## BULLETIN DETAILS

<b>Product Group:</b>	Power
<b>Model Effected:</b>	Tango
<b>Effective Date: 30-04-2015</b>	<b>Serial No. Effective From:</b> N/A
<b>Bulletin Subject:</b>	Tango Tilt Creep switch mounting assembly

Original design

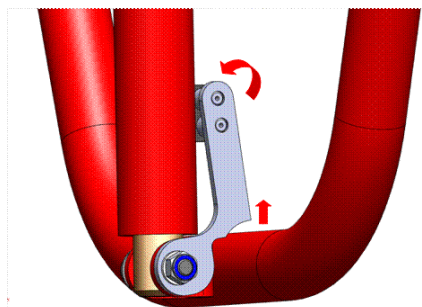
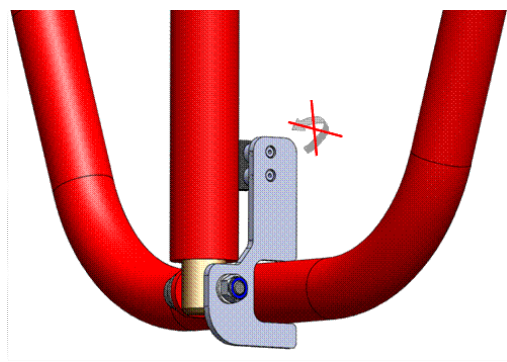
Through our feedback management system, we have received information that the material of the 034186 Tango Tilt microswitch mounting assembly (Aluminium) is not strong enough to fulfil the function adequately. It was deforming too easily, and the Tilt creep operation was not reliable enough. As a result the material was changed from aluminium to steel.

Also, part of the feedback was that the design of the assembly required a change in its geometry. When mounted on the chair, it was only touching the tube and there was the risk that it could rotate.

Material changes from aluminium to steel.

In addition the geometry of 034187 (Metal switch receiver plate) has been changed to have a 180° hugging part, to prevent rotation, and it will be square shaped and wider to prevent bending.
